HIROSE ELECTRIC CO., LTD.
2-6-3 Nakagawa Chuoh, Tsuzuki-ku, Yokohama, JAPAN**Product Specification Change for HIF3, B, C, M, and FX2B Series**

Supplementary Documentation for Product Changes in HIF3, B, C, M and FX2B Series

Hirose Electric Co., Ltd.
Engineering Group
Industry Division
PCC Engineering Section

Product Name and Changes of the Modified Items

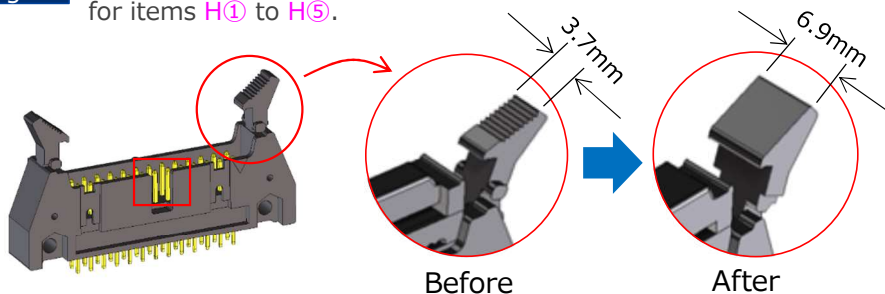
2.54mm Pitch Board-side Pin Header Group							2.54mm Pitch Cable Press-fit Socket Group
H① HIF3M*-W-PB -2.54DSA	H② HIF3M*-W-PB -2.54DS	H③ HIF3M*-W-PB -2.54WB	H④ HIF3M*-W-**PB -2.54DS	H⑤ HIF3MC*-W-PB -2.54DSA	H⑥ HIF3M*-W-PB -2.54DSA	H⑦ HIF3M*-W-PB -2.54DS	H⑧ HIF3M*-W-D -2.54R
Wide lock shape, straight type	Wide Lock Shape, Angle Type	Wide Lock Shape, Long Lead Angle Type	Wide Lock Shape, Double Layer, Light Angle Type	Wide Lock Shape Flux, Anti-Climb Straight Type	Wide Lock Shape Straight Type	Wide Lock Shape Straight Type	Wide Clamp Shape Type
[Changes] •Wide Lock Shape •Change in Terminal Plating Specifications					[Changes] •Change in Terminal Plating Specifications		[Changes] •Wide Clamp Shape •Change in Terminal Material •Change in Terminal Plating Specifications

Change 4

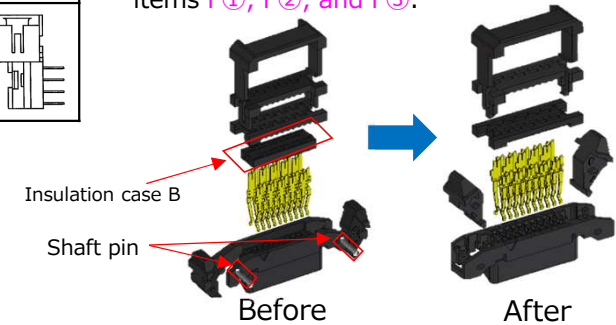
Change the number of parts used for items F①, F②, and F③.

Change 6

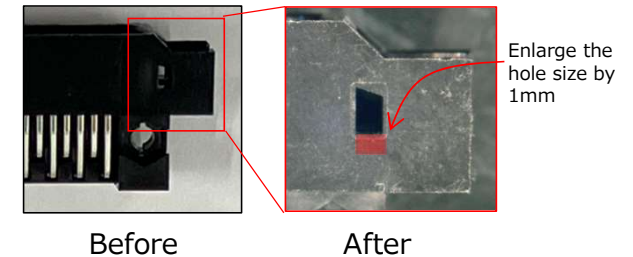
Change the hole size on the side of the insulation case for item F⑤.

Change 2

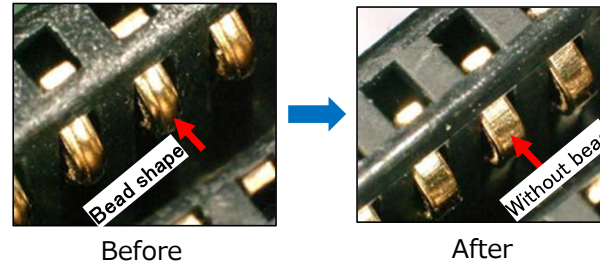
Change the terminal material of items F①, F②, and F③ (within copper alloy types) and modify the contact area shapes.

Change 3

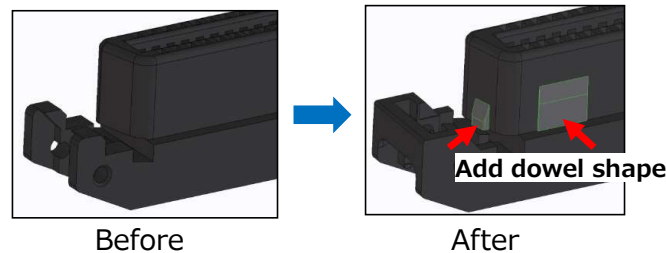
Change the side shapes of the insulation cases for items F①, F②, and F③.

Change 1

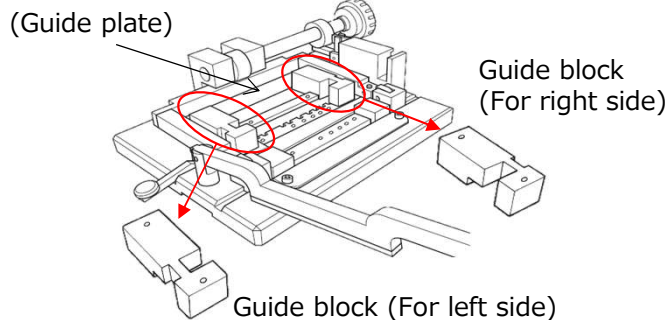
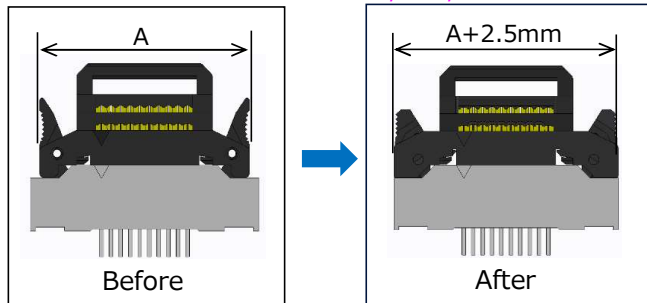
Change the lock shapes and external dimensions for items F①, F②, and F③.

It is necessary to purchase an additional set of guide blocks (left and right).

Part number for the left guide block: FX2BR-GPA(71)
Part number for the right guide block: FX2BR-GPA(72)
